SEWAGE DISPOSAL SYSTEM

MARYLAND STATE DEPARTMENT OF HEALTH*

SUBDIVISION Wayside Estates

0320 3616
ROAD Lynway Court

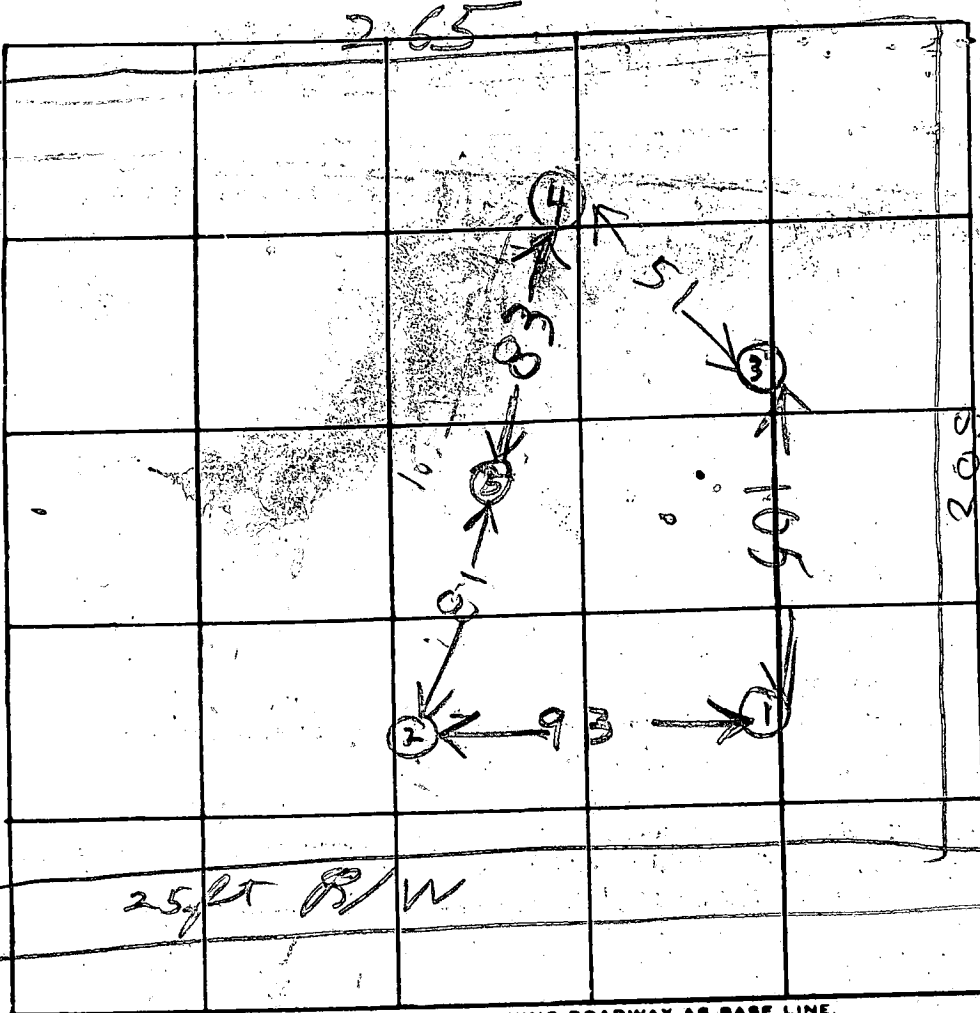
REMARKS *6/26/78 Spoke to Brittingham on site, Water at 12' in drywell excavation on 6/23 D.O. O.K'd changes see attached sheet - max depth 8 ft, inv. at 1 ft, cover system c 2' of fill S.S.*

LOT 4 SECTION 3

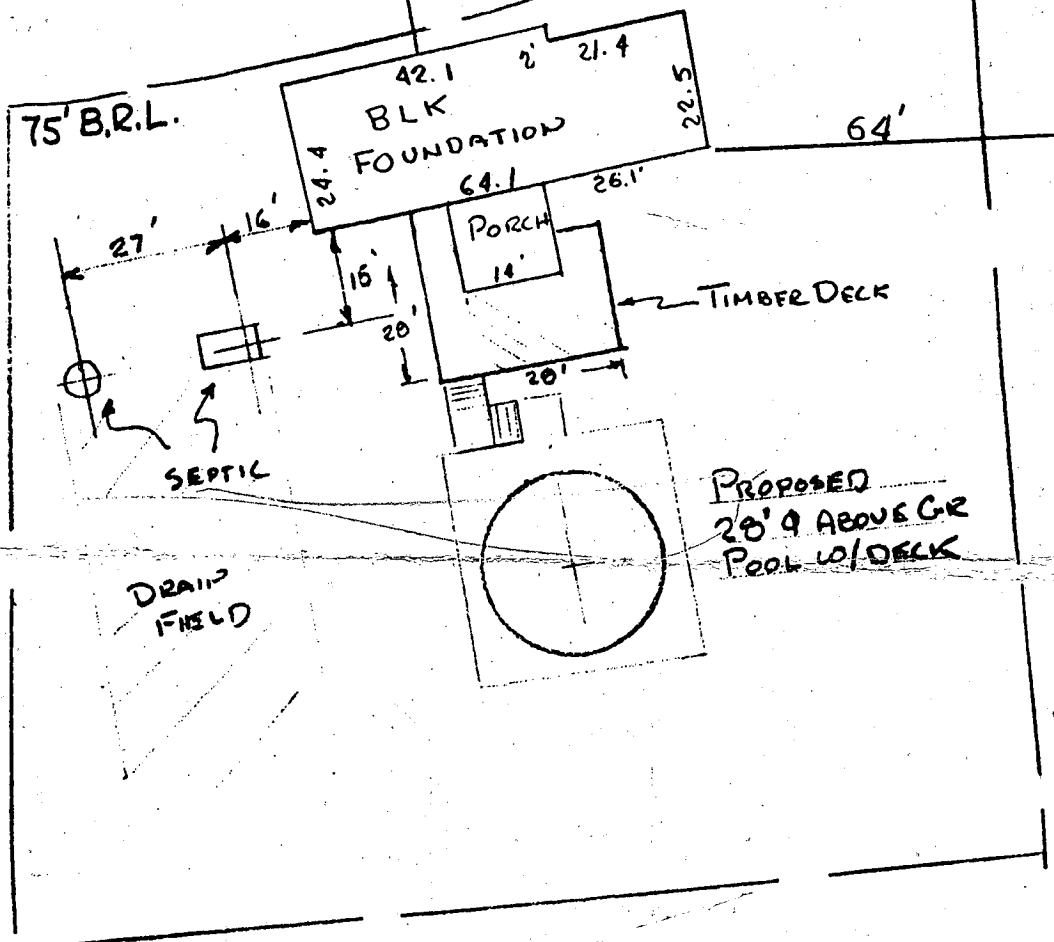
4/4/88 No problem
OK TO sign
PLOT PL

PLOT PLAN

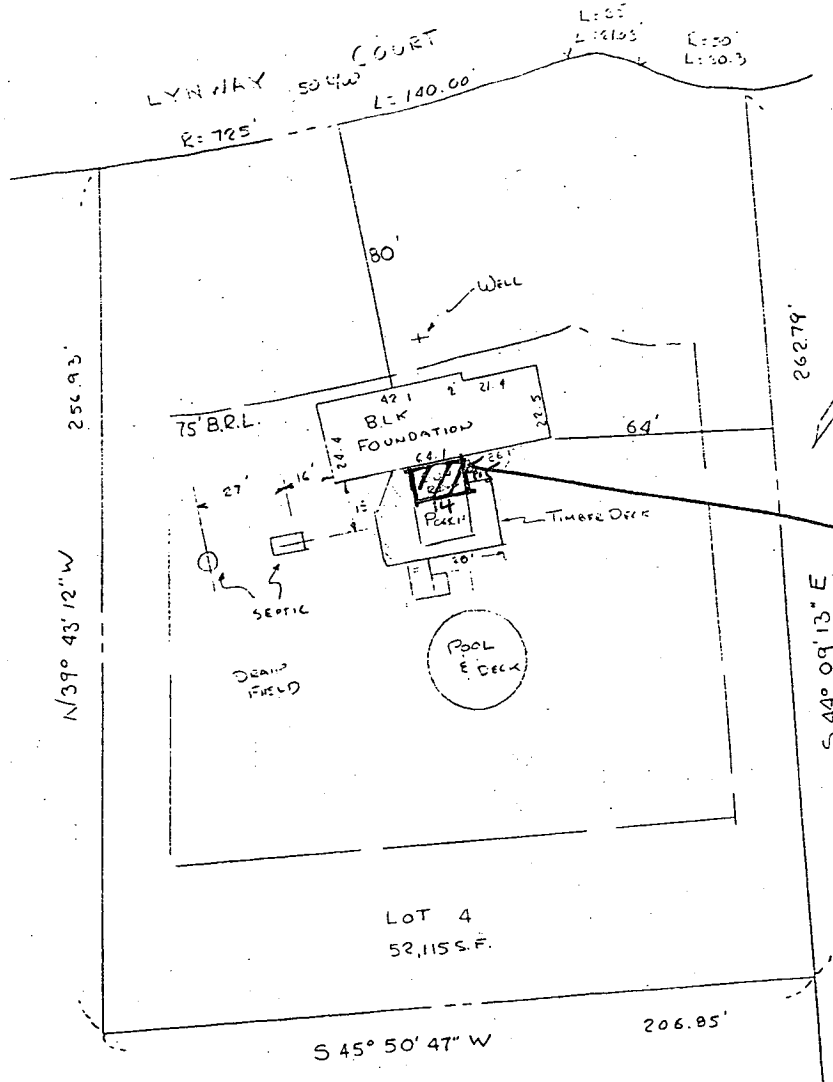
Permit is for enclosure
of this porch that extends
no more than 10 ft. from house
OK, F. J.
